**AGENDA**  
**Cascade Charter Township Planning Commission**  
**Monday, October 19, 2015**  
**7:00 pm**  
**Cascade Library Wisner Center**  
**2870 Jacksmith Ave. SE**

TO: Cascade Charter Township Planning Commission  
FROM: Steve Peterson, Community Development Director  
REPORT DATE: October 13, 2015  
MEETING DATE: October 19, 2015  
CASE: #15-3260 / Lacks Corporate HQ expansion

Re: Lacks Corporate Office  
Site Plan Review

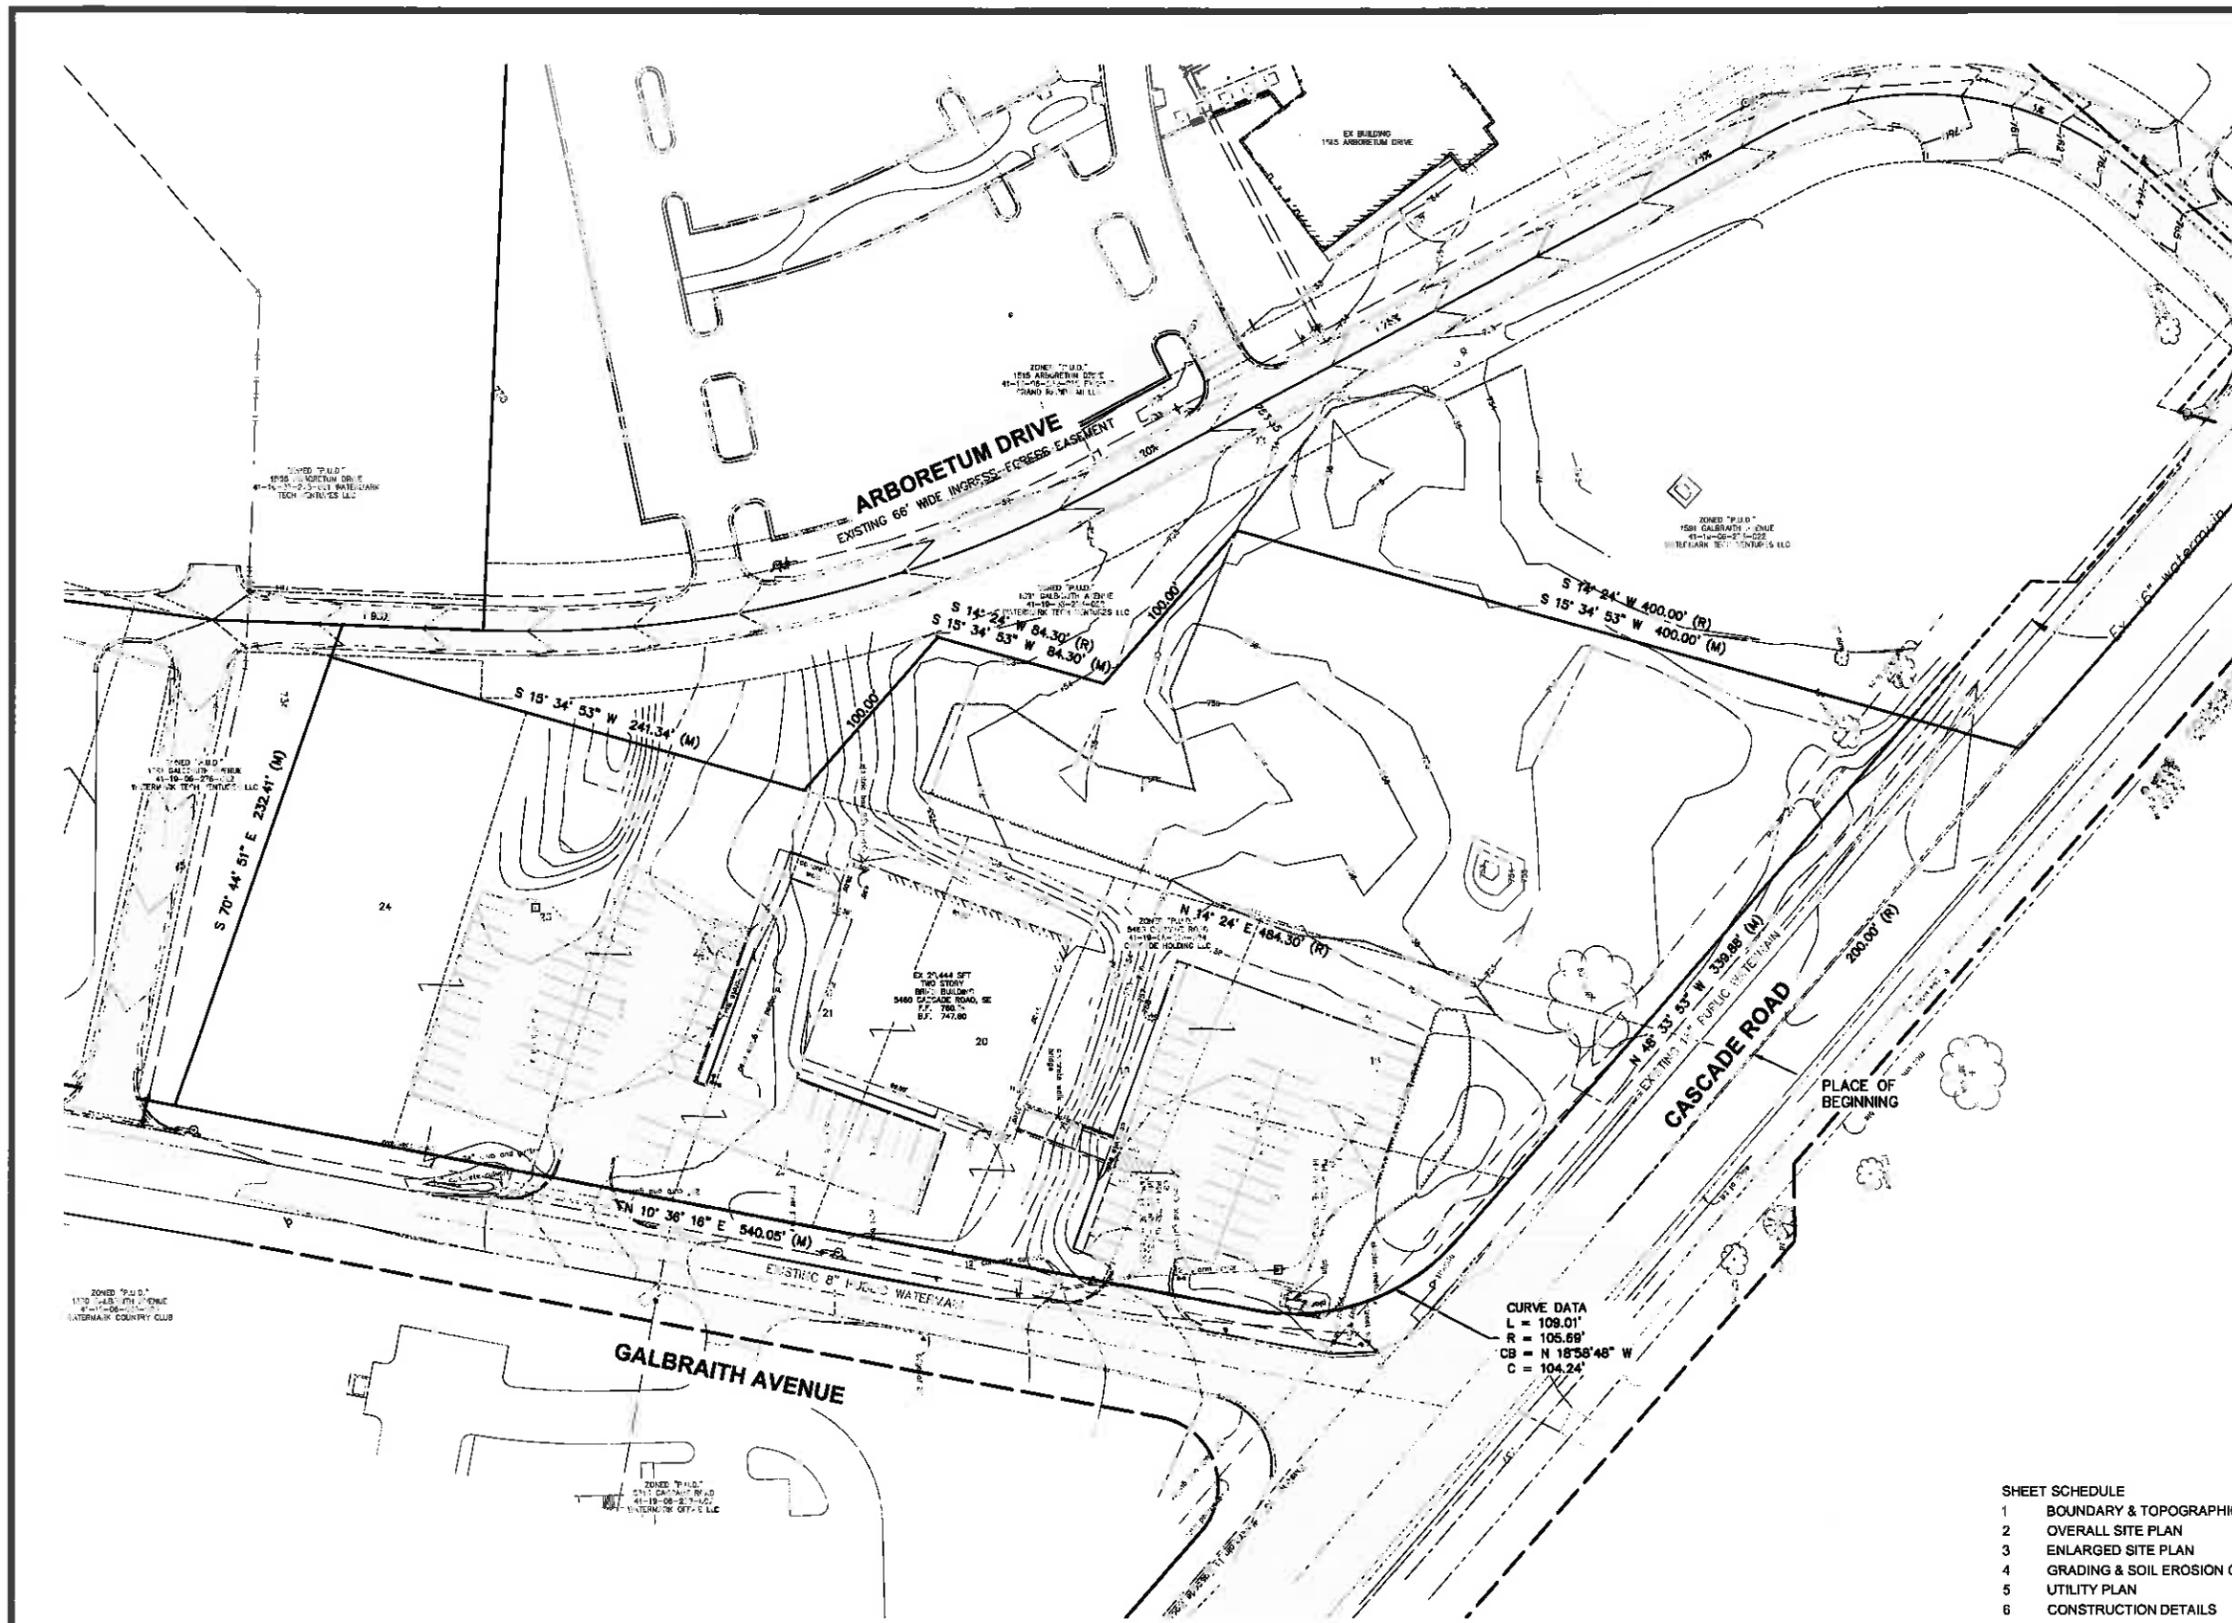
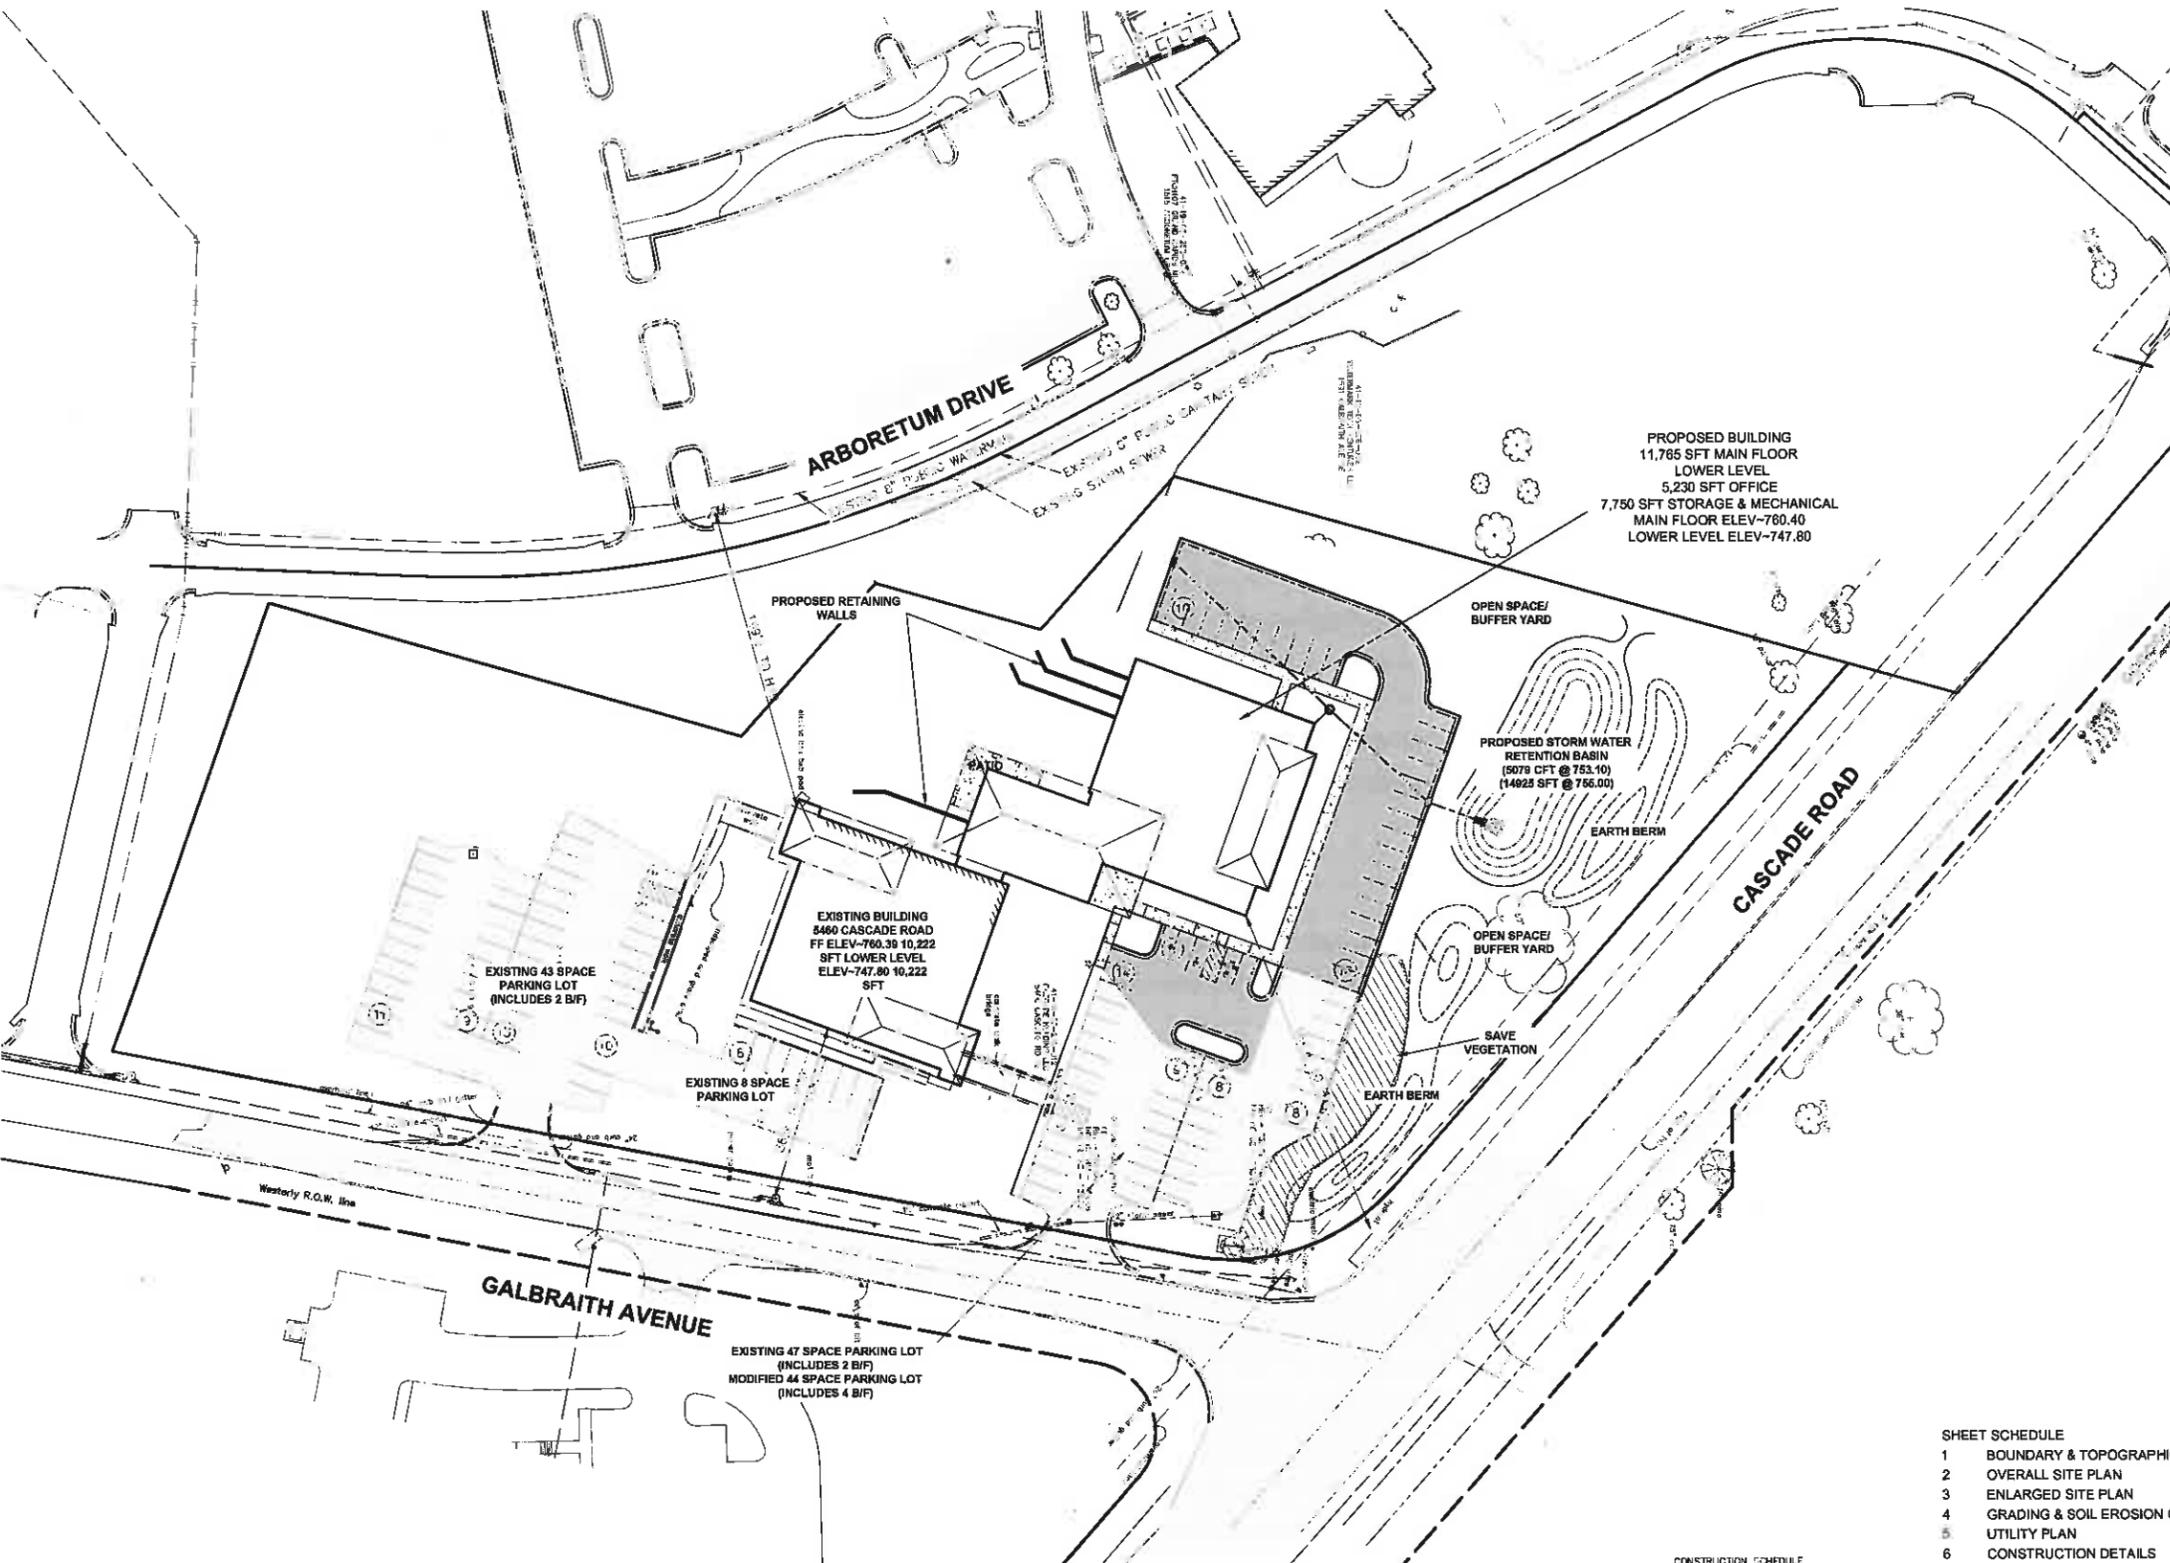
We reviewed the site plan for the Lacks Corporate Office, located at 5460 Cascade Road, prepared by Moore and Bruggink, Inc. The current site plan and the basis of this review are dated September 25, 2015. The proposed project includes a 24,745-square-foot building addition, parking lot expansion, and storm sewer improvements.

The applicant has submitted drawings, calculations, and additional documentation as required in the SWO Section 2.03, Drainage Plan. Please refer to the attached checklist for items and comments on each item. Please note a maintenance agreement is required before construction begins. The agreement should be submitted to the Township for review. The maintenance agreement and plan should include at a minimum, cleaning of catch basin sumps, sediment and debris removal from the infiltration basin, and landscape maintenance of the infiltration basin to maintain the design volume and ensure the system is operating as it was designed.

Soil Erosion and Sedimentation Control (SESC) measures are provided on the plan drawings. The applicant has included silt fence along the limits of clearing and grading, silt sacks in catch basins, and seeding with mulch at all disturbed areas of the site. SESC falls under the review and approval of the Kent County Road Commission and a permit is required before construction can begin. The SESC measures indicated on the drawings appear appropriate given the expected work.

The proposed stormwater design meets the Township SWO requirements for new developments. The applicant will need to apply for and obtain an SESC permit prior to beginning construction. We recommend approval of the site plan from an engineering standpoint.

- NR (11) Maintenance agreement, in form and substance acceptable to the Township, for ensuring maintenance of any privately owned stormwater runoff facilities. The maintenance agreement shall include the developer's written commitment to provide routine, emergency, and long-term maintenance of the facilities and, in the event the facilities are not maintained in accordance with the approved drainage plan, the agreement shall authorize the Township to maintain any onsite stormwater runoff facility as reasonably necessary, at the developer's expense  
*Maintenance agreement was not provided and is required.*

Listed below are items from the site plan review:

- Fire Lanes will be determined by the Fire and Building code Officials.
- Access to the site at all times during construction.
- Hydrants and spacing will be determined by the fire code official and the City of Grand Rapids water department. On plan hydrants are difficult to find, 300 feet spacing along access roads.
- Fire Department Connection (FDC) will be a 5" Stortz fitting with a 30 degree elbow.
- Address posted and visible from the roadway.
- Supra box installed for 24 hour access by Fire Department staff in case of an emergency.
- Access will need to be for fire trucks from Galbraith to Arboretum thru the new parking lot. Appears there are parking spaces on the plan.
